May 19, 2015

SUBJECT: DRAFT EVALUATION OF GOLDER REPORTS – SODA CREEK P4
(MONSANTO) WATER RIGHTS TRANSFER

Figure 1 Model domain and locations for AQTESOLV Modeling. The characteristics of the model domain are varied in the AQTESOLV calculations as described in the following figures.

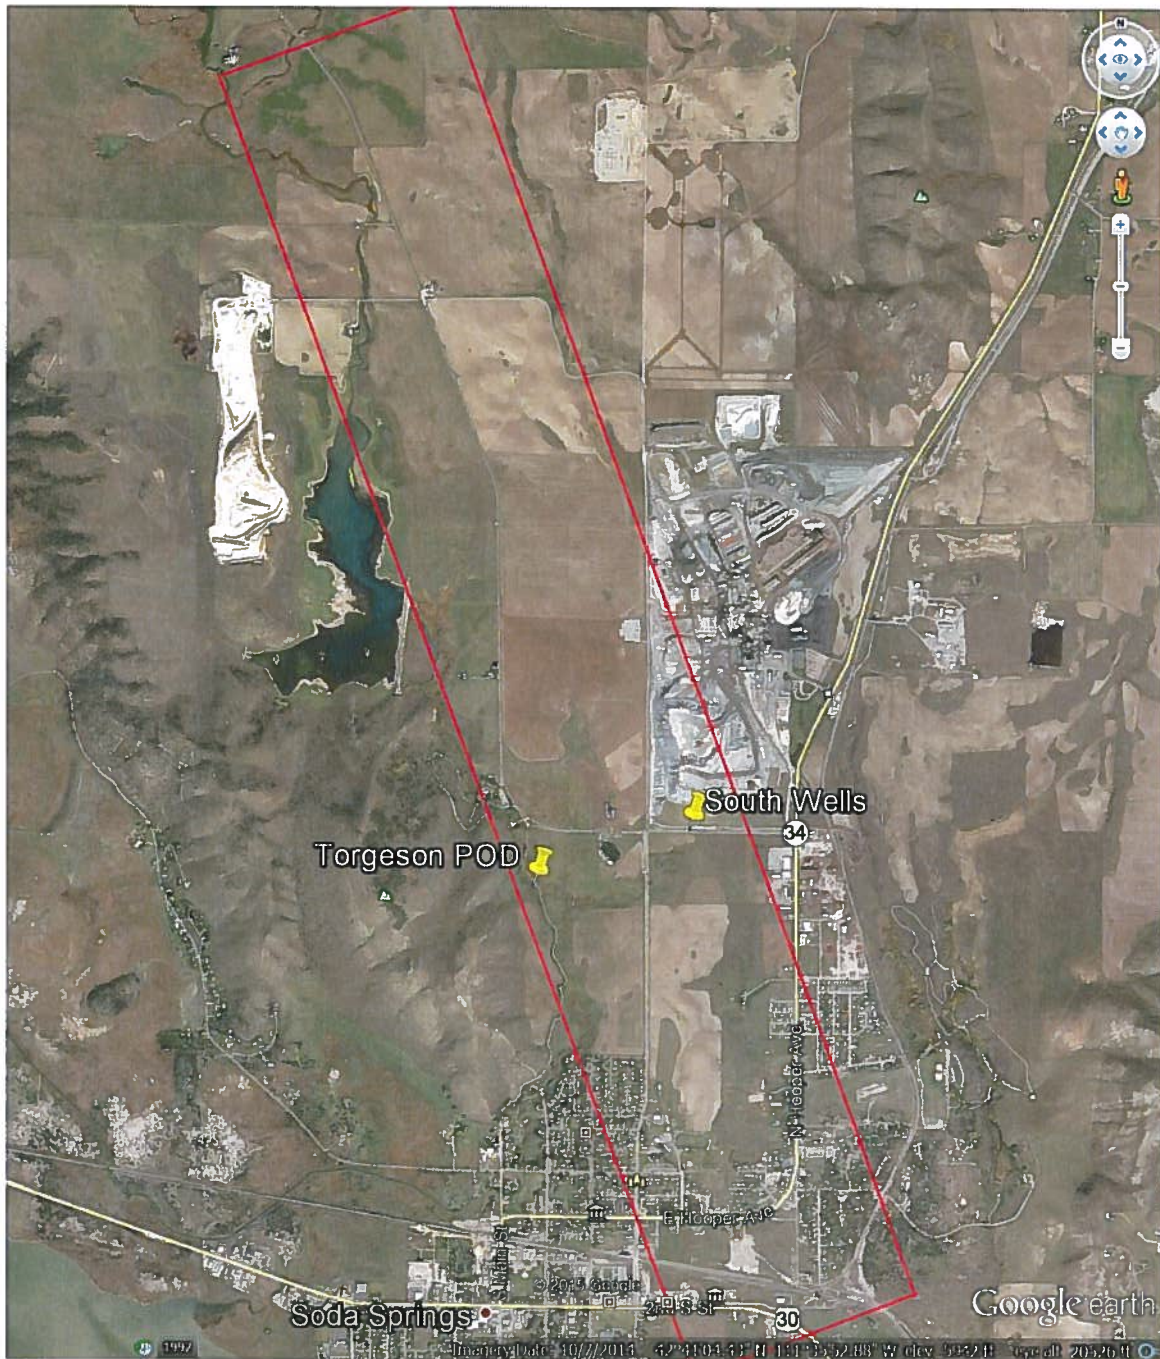
- g. Figure 1 shows the domain of an AQTESOLV model that is 4200 ft wide and 24,200 feet high. The east and west sides are no flow boundaries representing the hydraulic barrier (faults) and Chester Mountain, respectively. I have run AQTESOLV for different boundary conditions using numbers from Golder; Transmissivity of 60,000 ft²/day and Storativity of 4.3 e-4.

Figure 2 No aquifer boundaries, i.e. Theis assumptions of infinite aquifer. Plot is a Theis curve generated using Golder Data; T=60,000 ft²/day and S = 4.3e-10-5. Lines represent calculated aquifer drawdown over time for the following locations.

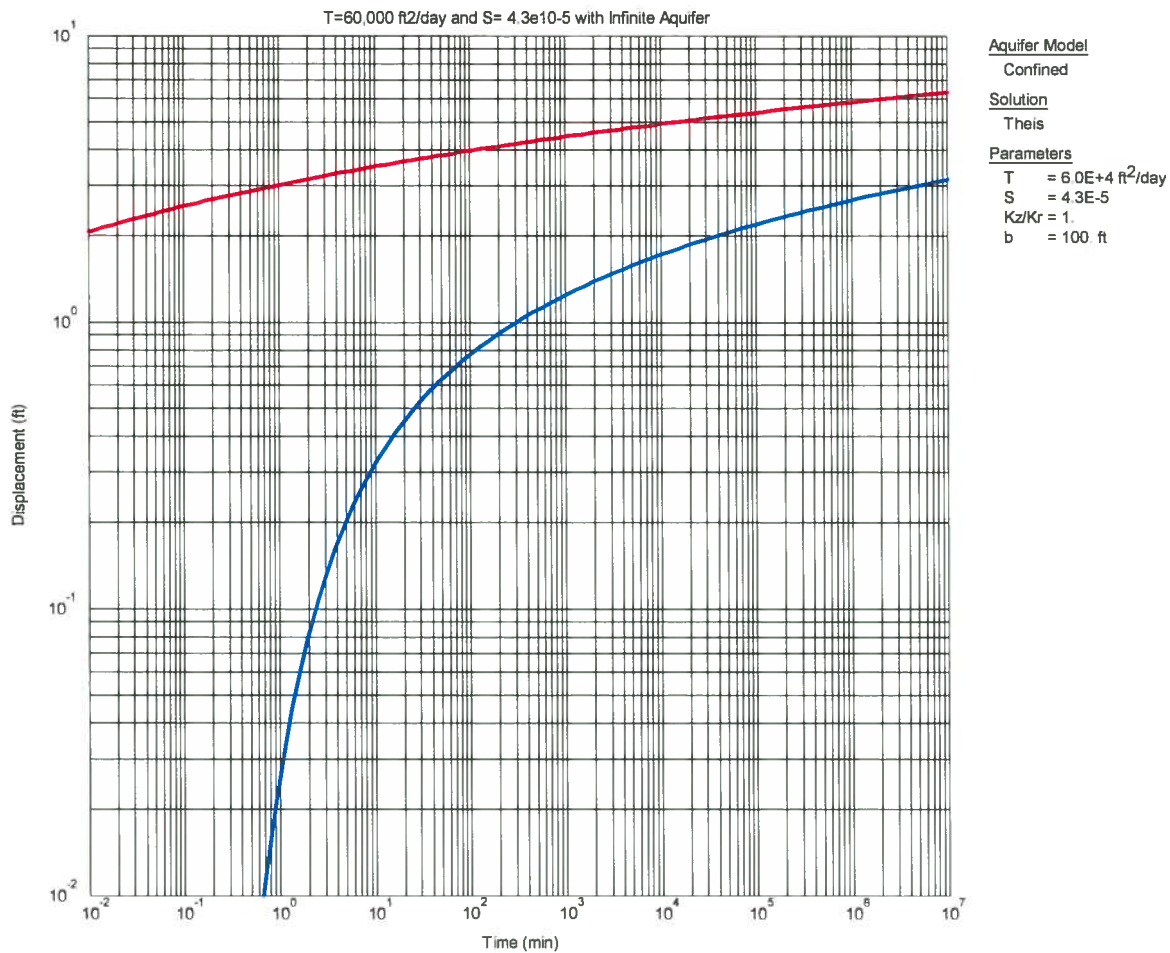
- i. Figure 2 is an infinite aquifer with no boundaries. This represents Golder Case c.
 - ii. Figure 3 is a model with no flow boundaries on east and west. A constant head boundary is enabled at the north end such that the model pulls unlimited water out of Five Mile Meadows area. The water level declines level off after a time because an infinite amount of water can be pulled from the area of Five Mile Meadows.

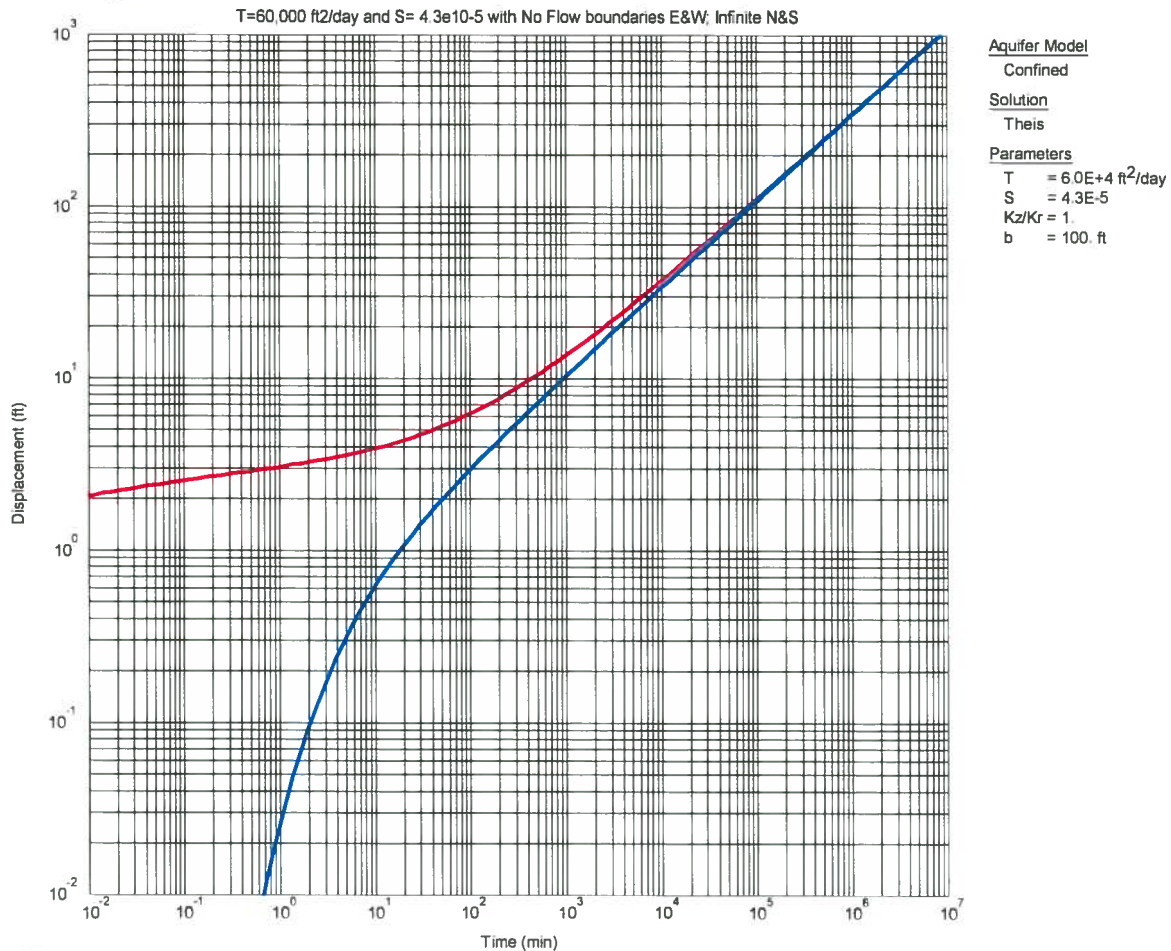
- iii. Figure 4 is a model with no flow boundaries on the east and west and no boundaries on north and south (no boundaries means that the aquifer is infinite in the north and south direction, as in an infinite Theis Model). This model shows what happens if no new water is allowed to enter the model from a source such as a stream or other recharge. It is unrealistic but it does show that water has to enter the aquifer from somewhere.

- iv. Conclusion from this evaluation is that the actual decline of aquifer head is much greater and the vertical hydraulic gradient controlling leakage from Soda Creek is many times greater when the aquifer boundaries are considered.

Figure 5 Relation of storage change and streamflow depletion.

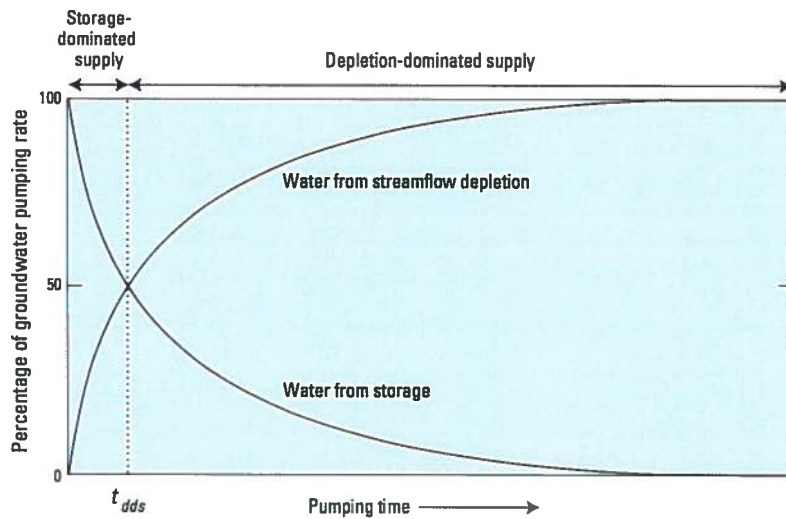
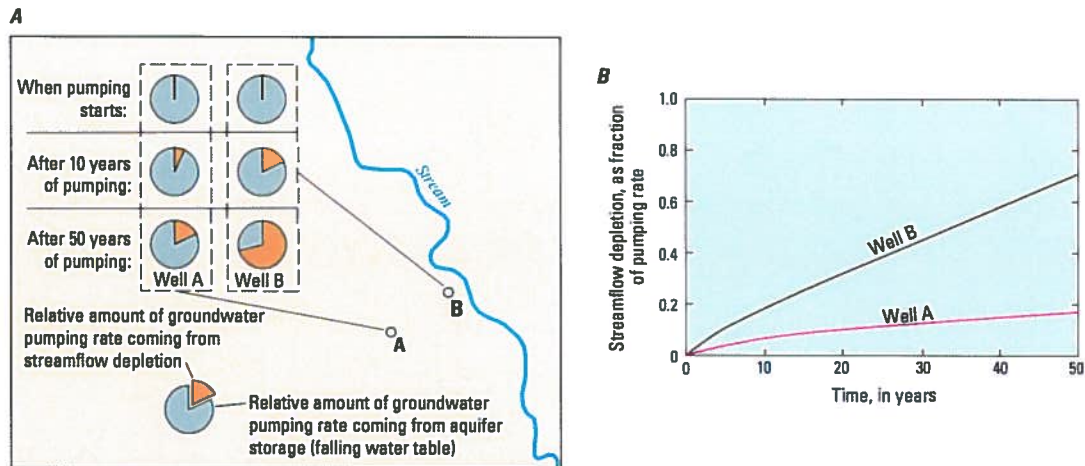
- ii. In the Golder analysis, generally a time of one year was used for pumping. This will show LESSEned impacts because the wells will pump continuously for years and years. As pumping time increases, drawdown will also increase, and therefore increase stream impacts. This is depicted in Figure 5. Water initially comes from storage and as time goes on, more and more water comes from the stream. At the bottom of Figure 5 the USGS report indicates that this cross over time is measured in years. One year modeling is insufficient.
